PROPOSED EXTENSION TO
40 - 42 HIGH STREET,
HOLBEACH TO PROVIDE
SHOP & FLAT FOR

SKETCH

1:50 1:100 FB07-010/4

FRONT

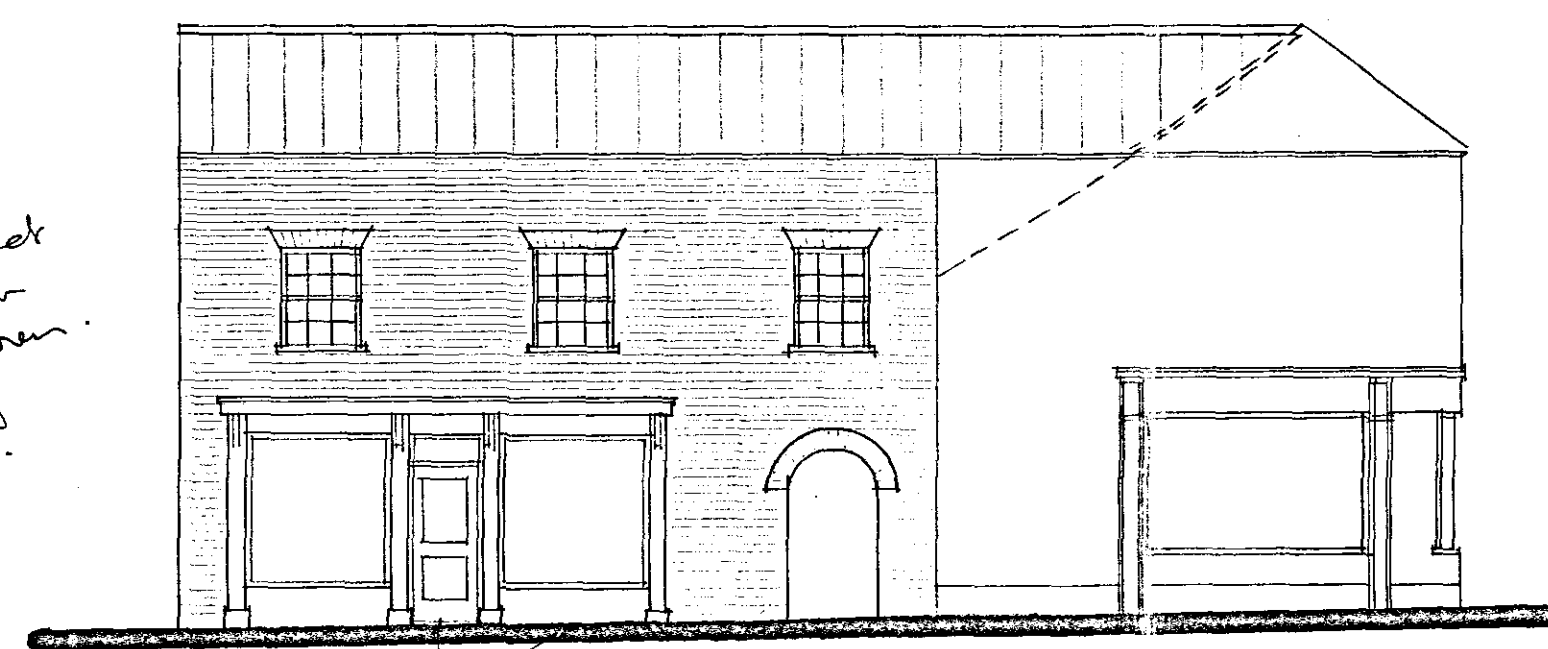
Windows set
for far down
the elevation.
lots of
space.

Shopfronts appear
discontinuous compared
to host building.

SIDE

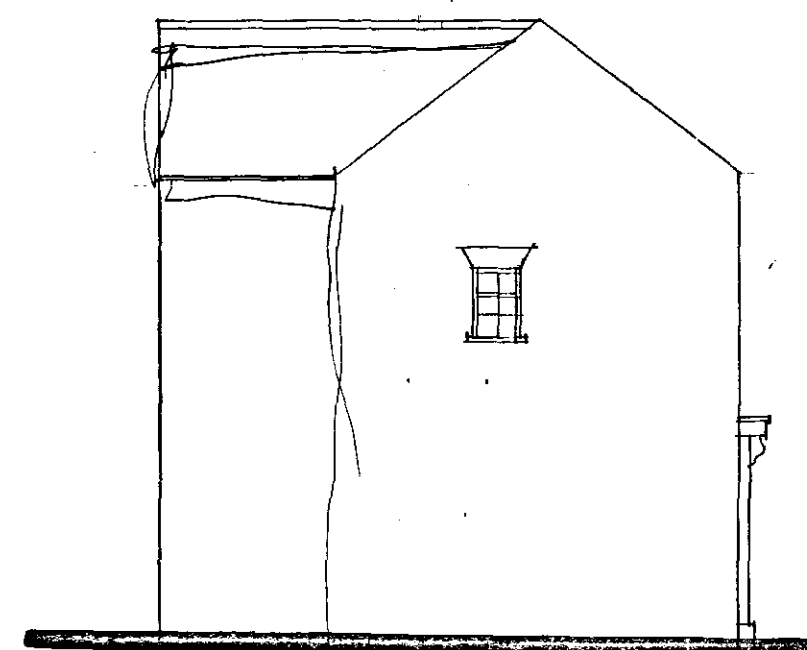
door panel
to better of

door should
use large

not full rise
vertical substructure.

better detail to
carriage brackets - for finish
- Pasco - all things deeper - no railing
nor structural

rear profile to be
substantive
